**GUARDIAN SELF STORAGE**

#99-8  
GUARDIAN SELF STORAGE S.P.  
SQUARE HILL ROAD (HAZEN)

**SUBJECT: GUARDIAN SELF-STORAGE SITE PLAN (P.B. # 99-8)**

**REVIEW NAME:** GUARDIAN SELF STORAGE SITE PLAN  
**PROJECT LOCATION:** SQUARE HILL ROAD (a/k/a LINER ROAD)  
SECTION 4-BLOCK 1-LOT 4  
**PROJECT NUMBER:** 99-8  
**DATE:** 9 JUNE 1999

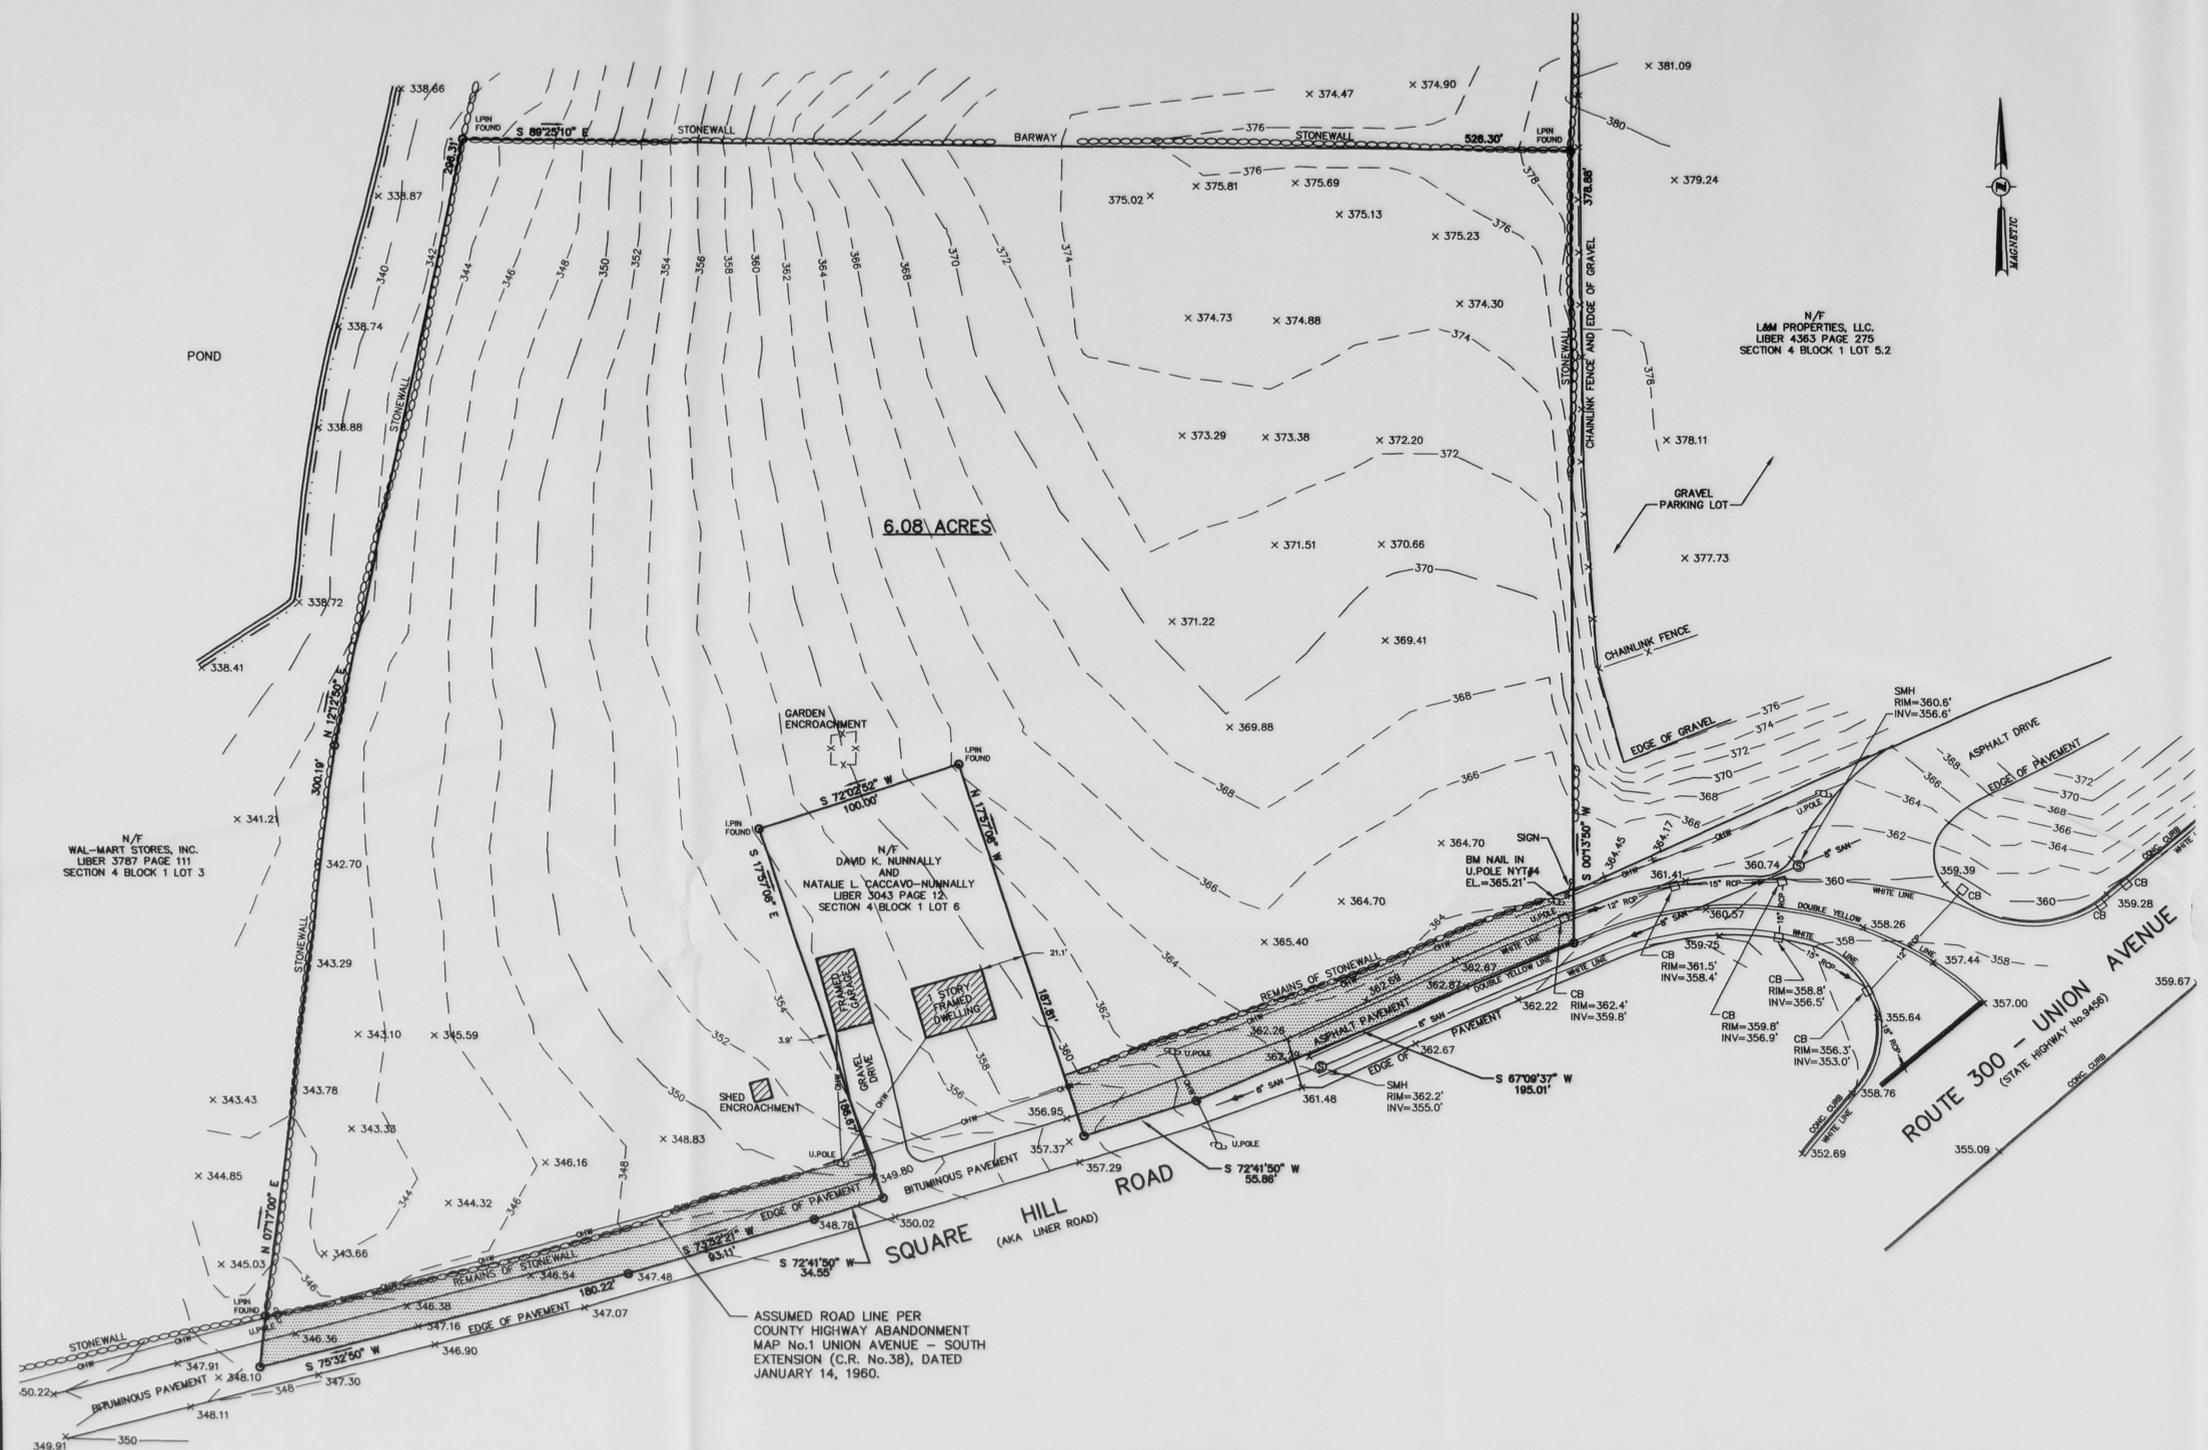
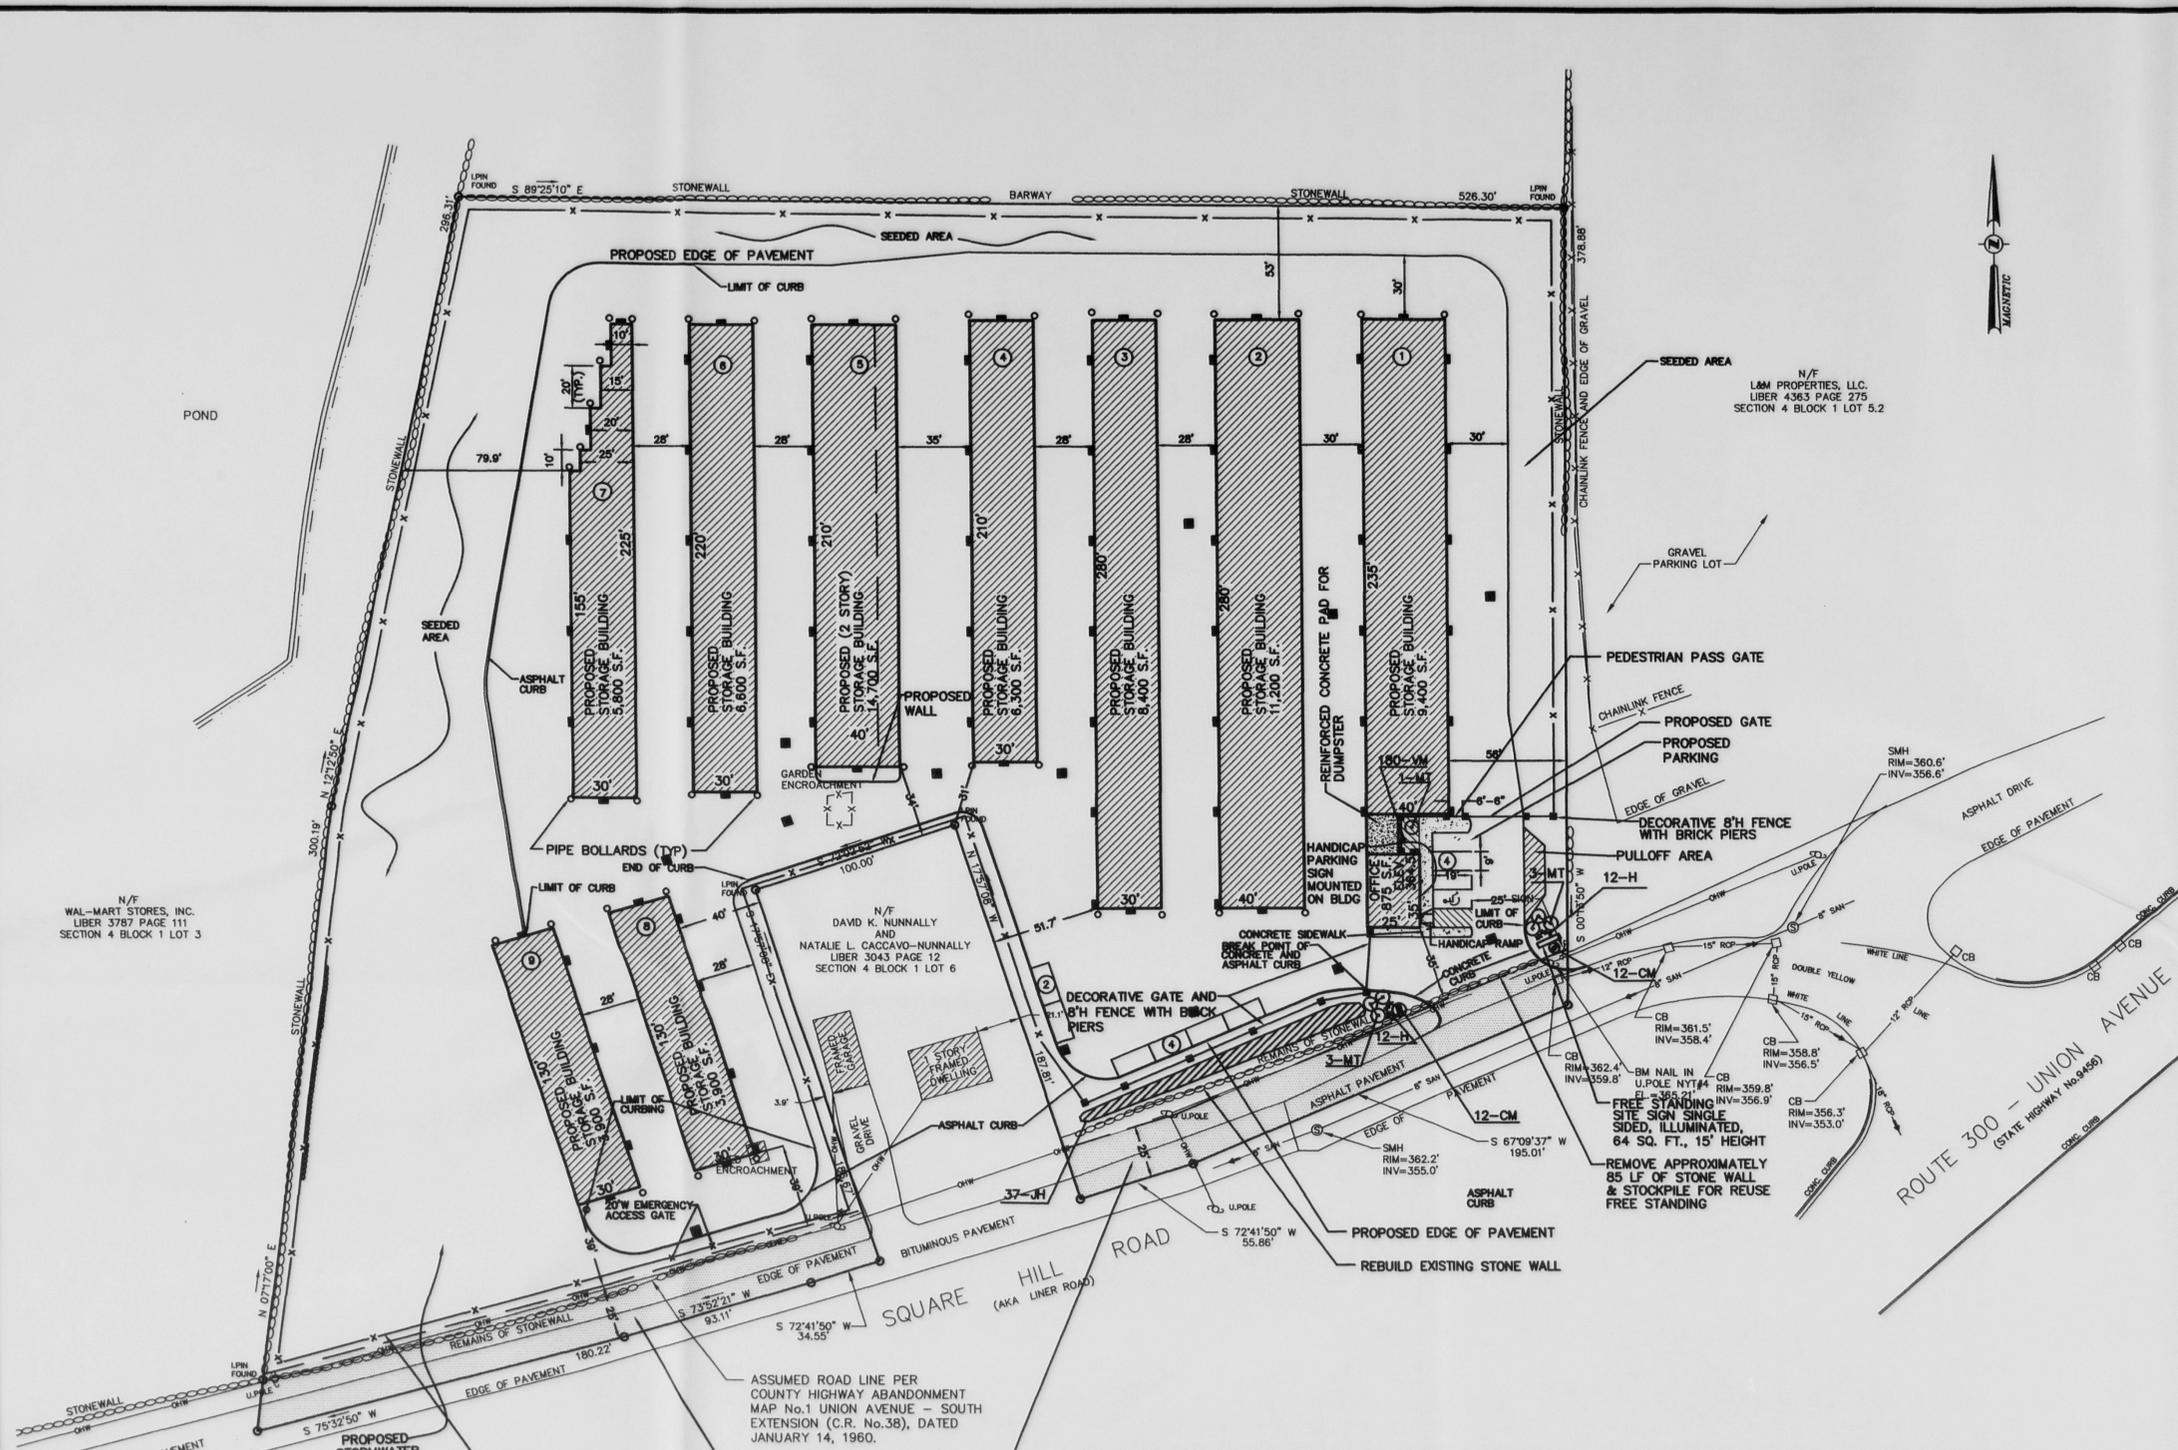
2. The detention pond, as designed, will contain 4.4 feet of water below the discharge of the outlet control structure. No method of discharge for this water is provided. The Town of New Windsor Policy requires detention ponds drain between storm events. The capacity of the first flush treatment would be significantly diminished if existing water was contained in the pond prior to the storm event. A low flow outlet of some sort should be provided in order to provide for draining of the pond between storm events.

3. A section of rip-rap slope protection is identified on the plan sheets, however, a catch basin could be provided at the location of the rip-rap slope protection discharging to the detention pond inlet. This would eliminate the need for over land flow in this area and would allow for the installation of curbing as depicted on the site.

- d. The bulk table should delete the word "minimum" relative to the proposed storage unit height.
  - e. Additional explanation should be provided as to the purpose of the "rip-rap slope protection" depicted on Sheet C-3. Further, explain why this is only provided in the limited area shown.

The bottom of the basin was raised from elevation 340 to 344.5 and the basin was reconfigured. An exfiltration system was added to provide for draining of the pond between storm events.
